CITY OF LAGUNA HILLS

July 11, 2023

**SUBJECT: SITE DEVELOPMENT PERMIT NO. 0147-2023 (LA PAZ VILLAGE SENIOR LIVING)
COMPLETENESS REVIEW**

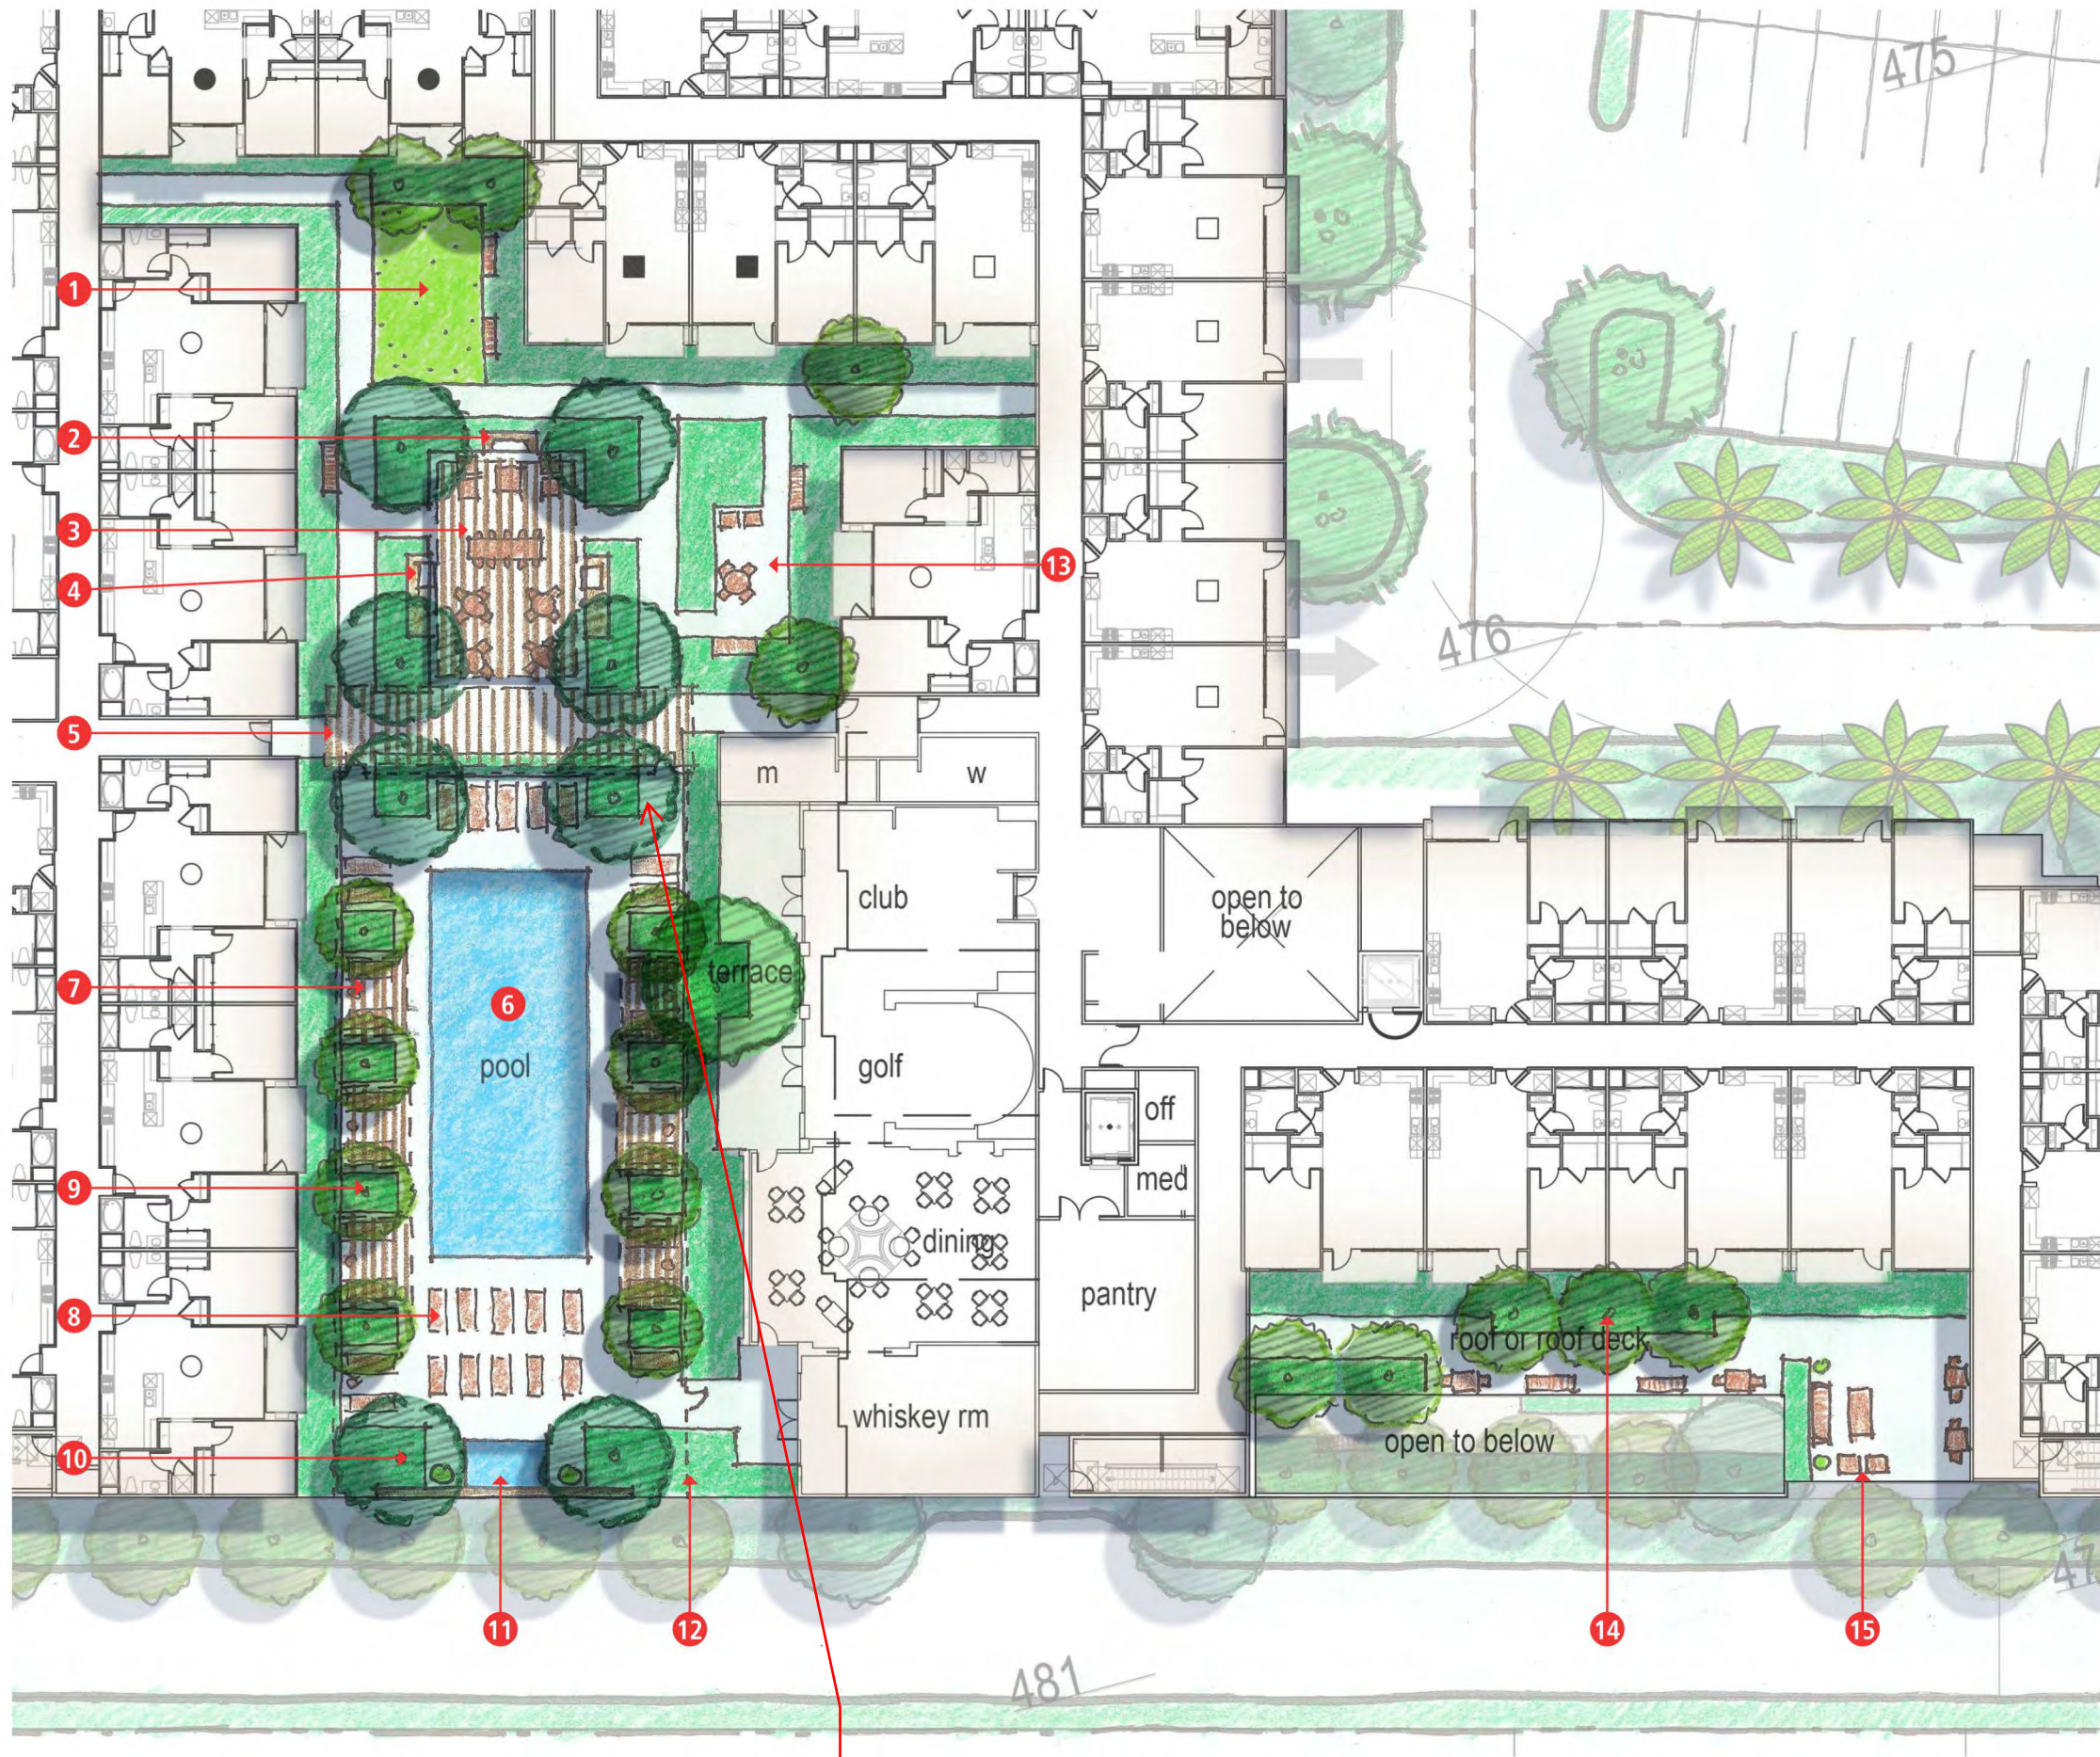
Vegetation & trees obstruct the proposed Fire lane
